Subject: License Amendment Application to Revise Technical Specification 3/4.4.5, Steam  
Generators, Regarding Steam Generator Tube Repair Roll Requirements (License  
Amendment Request 01-0004)

APPLICATION FOR AMENDMENT  
TO  
FACILITY OPERATING LICENSE NUMBER NPF-3  
DAVIS-BESSE NCLEAR POWER STATION  
UNIT NUMBER 1

Proposed Change to Technical Specification 3/4.4.5, Steam Generators, to Revise Steam Generator Tube Repair Roll Requirements

Figure  
Tube Repair Rolls

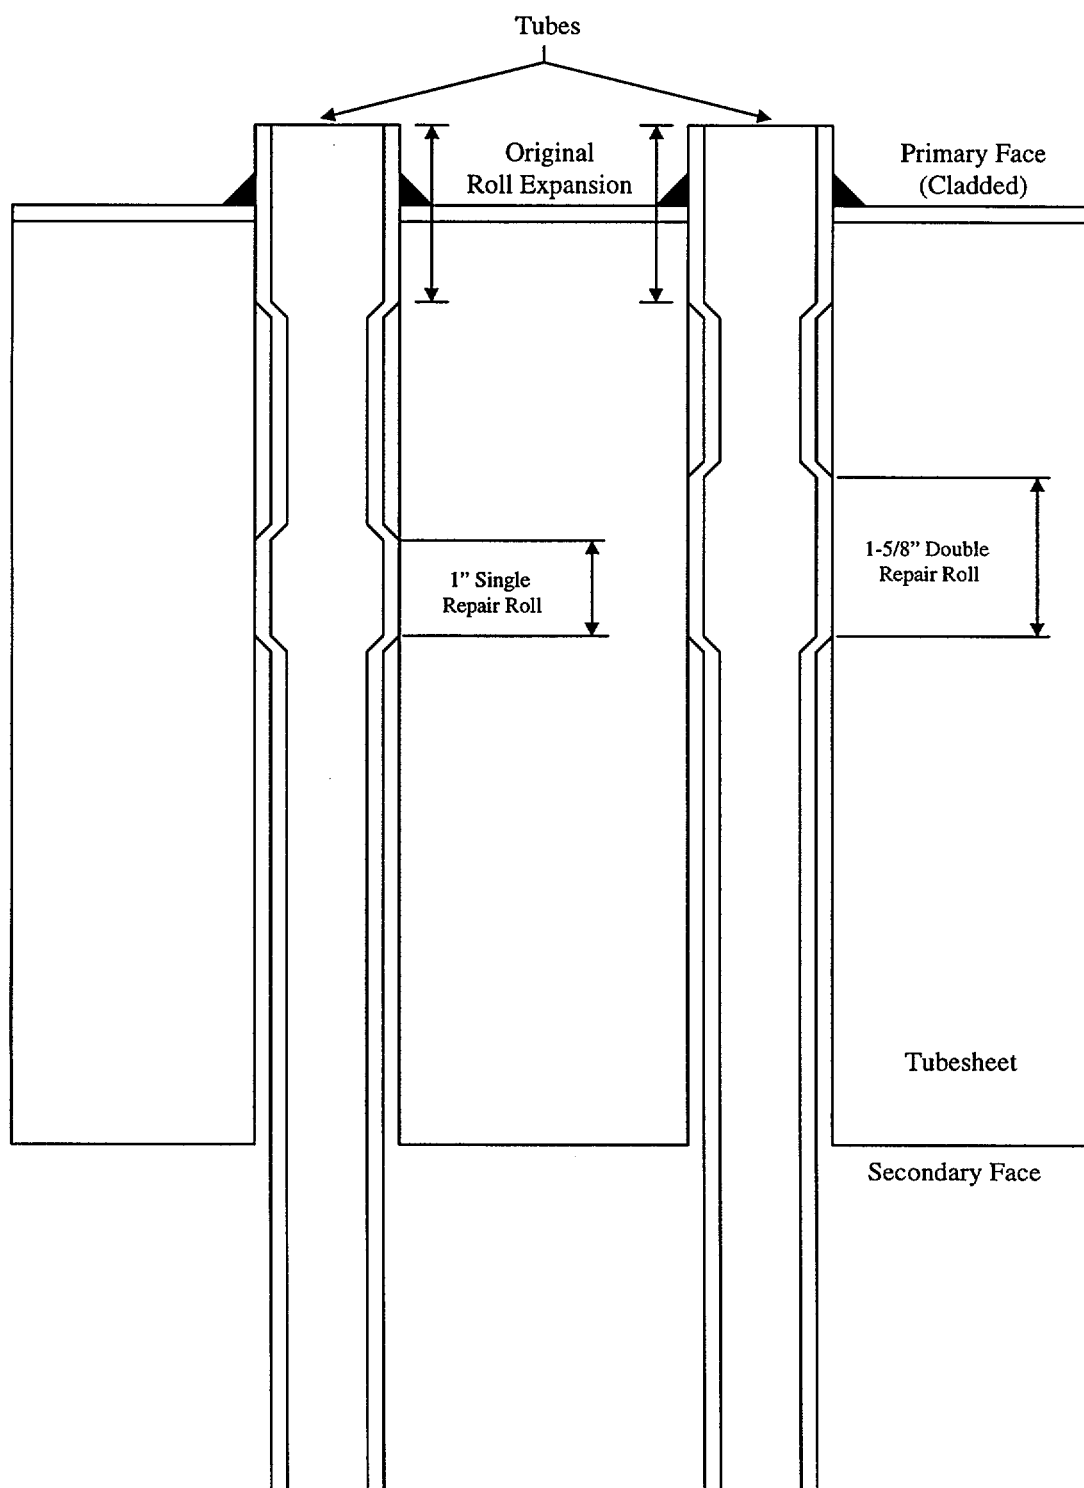
The repair roll method being modified in this License Amendment Request (LAR) provides a method of repair for steam generator tubes that have sustained degradation of the tube within the steam generator tubesheets. The repair roll is a process whereby a new primary to secondary pressure boundary joint is established by hard rerolling the tube closer to the secondary face of the tubesheet. The new pressure boundary joint is established to remove the area of degradation from pressure boundary service (see attached figure).
